April 1, 2024

Town of Rolesville  
Planning Department  
502 Southtown Circle  
Rolesville, North Carolina 27571

**RE: Pearce Farm**  
**Case Number: PSP-23-04**  
**Response to 1<sup>st</sup> PSP Review Comments**  
**AGN-23001**

#### MEMO – Sheet C8.01 Site Details

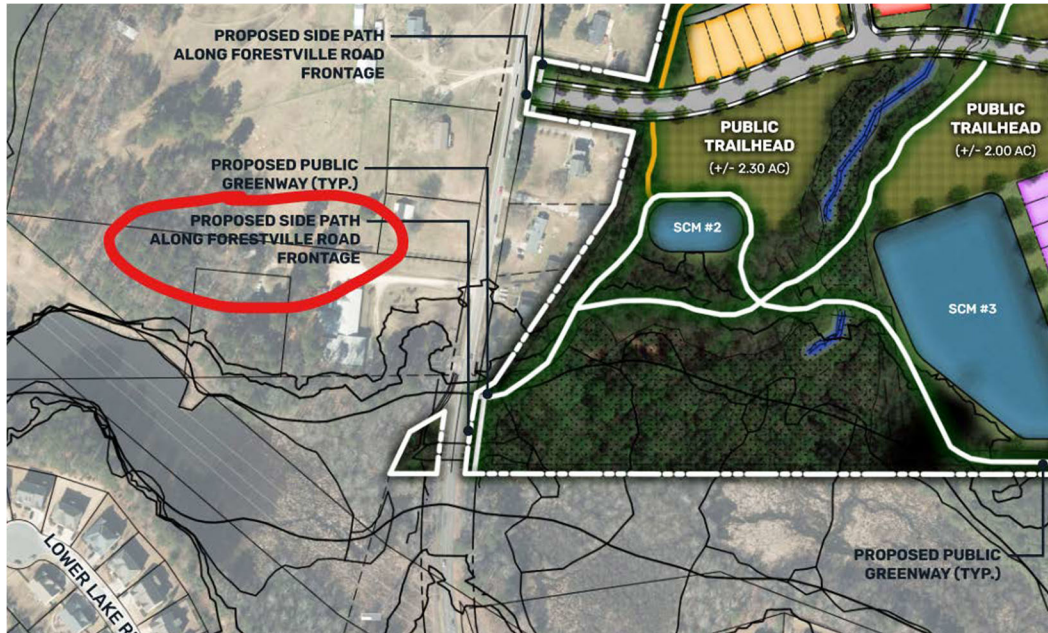
87. Please update the detail sheet to reflect the following.

- > NCDOT sidewalk / curb ramps / notes (848.05)
- > Pedestrian ramps shall be designed and constructed to meet the latest requirements per NCDOT for pedestrian ramps located in public right-of-way. Pedestrian ramps located outside of right-of-way shall be designed and constructed to meet the latest accessibility requirements in the North Carolina Building Code.

**McAdams Response: All accessible ramp details have been replaced with the latest NCDOT standard drawings 840.06.**
